Access Compliance Report

Public Rights-of-Way

(Curb Ramps)

Intersection ID: 21517	Main Street: BELLECHASSE_ST	Cross Street: COTILLION_AV	Location: SE
ADA ID: 09B3CF86E044	Ramp Type: PerpDiag	Initial Pass/Fail: Fail	Overall Compliance: No
		Severity Score: 22.5

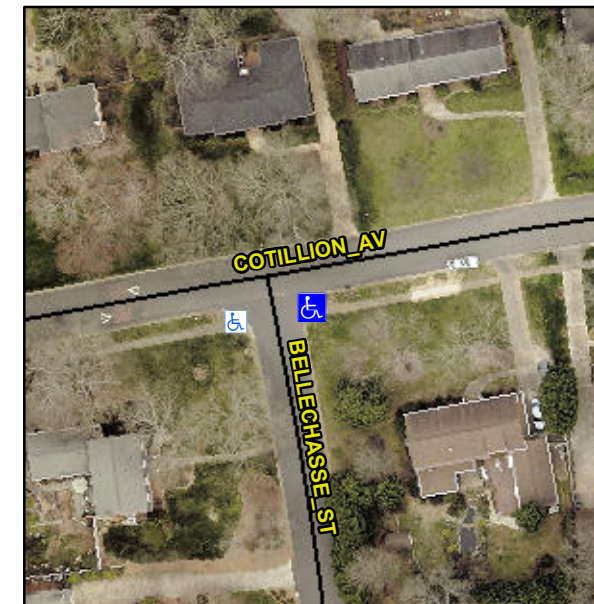
Not Found, R304.5.1, R304.2.2, R304.5.3

Compliance	Description	Data	Compliance	Description	Data
N/A	Ramp Length (in)	87.0	No	Ramp Slope (%)	11.3
No	Ramp Width (in)	43.0	No	Ramp XSlope (%)	3.3
N/A	Flare Type LT	N/A	N/A	Flare Type RT	N/A
N/A	Flare Slope LT (%)	N/A	N/A	Flare Slope RT (%)	N/A
N/A	Flare Traversable LT?	N/A	N/A	Flare Traversable RT?	N/A
N/A	Landing Length (in)	N/A	N/A	DWS Provided?	N/A
N/A	Landing Width (in)	N/A	N/A	DWS Contrast?	N/A
N/A	Landing Slope (%)	N/A	N/A	DWS Length (in)	N/A
N/A	Landing X Slope (%)	N/A	N/A	DWS Full Width?	N/A
N/A	Landing Curb? (Y/N)	N/A	N/A	DWS Offset (in)	N/A
N/A	Shared Landing?	N/A			
N/A	Gutter Ponding?	N/A	N/A	Gutter Slope (%)	N/A
N/A	Gutter Lip Ht (in)	N/A	N/A	Gutter X Slope (%)	N/A
N/A	Painted X Walk1?	No	N/A	Painted X Walk2?	No
	X Walk 1 Direction	To N		X Walk 2 Direction	To W
N/A	X Walk 1 Width (in)	N/A	N/A	X Walk 2 Width (in)	N/A
	X Walk 1 Slope (%)	6.0		X Walk 2 Slope (%)	0.2
	X Walk 1 X Slope (%)	1.6		X Walk 2 X Slope (%)	0.5

Remove & Replace Curb Ramp With Two New Directional Ramps or Equivalent.
